Subject: Requesting Class II permissive change for FCC ID: O57TB3710F

The purpose of this letter is to request a Class II Permissive change for FCC ID: O57TB3710F, original granted on 16/10/ 2015.

Please see below the layout of Version 2.0 and 3.0 for reference.

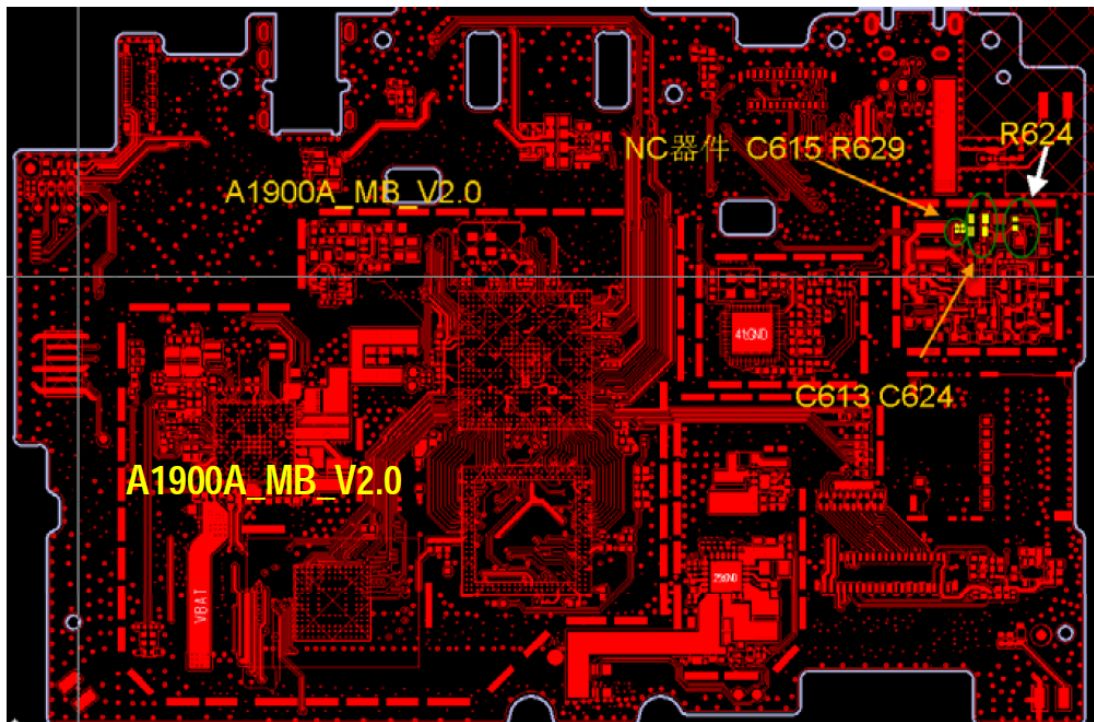
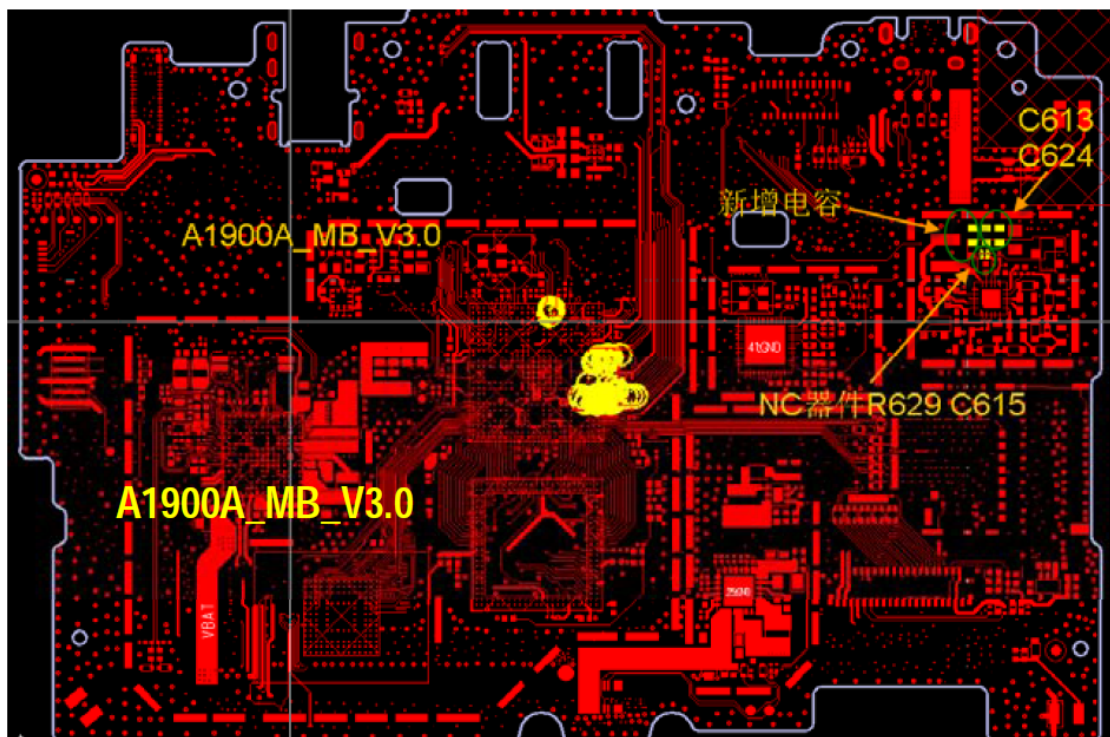
1. Add below second source for 16GB Memory-EMMC.
Model: THGBMFG7C2LBAL
Supplier: Toshiba
2. Add second source for USB cable.
3. The PCB is changed from Version 2.0 to Version 3.0. The changes between the two versions are as following:
 - a. The location of NC Part (0201) C615 and R629 is changed slightly.
 - b. Part R624(0402) is removed.
 - c. Part (0603)C609 with height 1.0mm is new added.
 - d. C613 and C624(0603) is rotated in 90 degree and the layout is change accordingly.
